Application No. 10/656,324
AMENDMENT C dated April 3, 2006
Reply to Office Action of November 2, 2005

REMARKS

FIG. 1

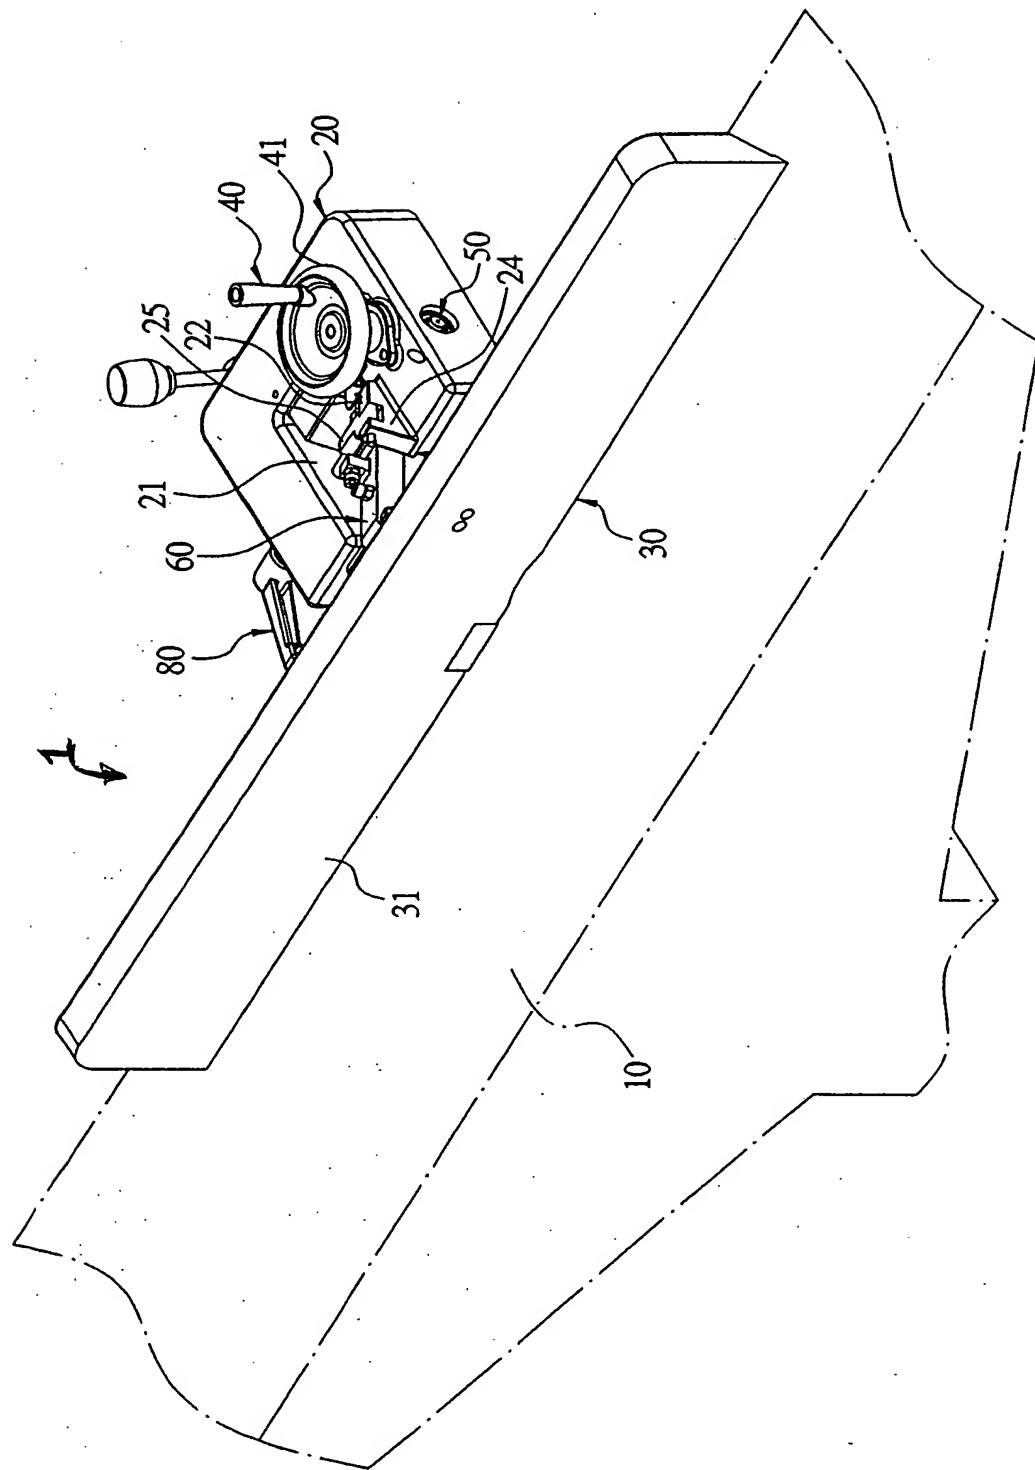
The drawings were objected to under 37 C.F.R. §1.83(a) for failing to show each and every feature of the invention specified in the claims. More particularly, the drawings were objected to because they fail to show a “planar” and a “base,” as recited in previously submitted claim 21. Applicants submit that Fig. 1 has been amended to include reference numeral “1” and paragraph 0015 of the specification has been amended to clarify that reference numeral “1” pertains to the “planer” discussed throughout the application. Claim 21 has also been amended to eliminate the objectionable “base” language. Support for these amendments can be found throughout the application, and in particular in paragraphs 0001 and 0004 to 0015, the abstract and original claims of the application, and in drawing Fig. 1.

Annotated sheet showing the change made to Fig. 1.
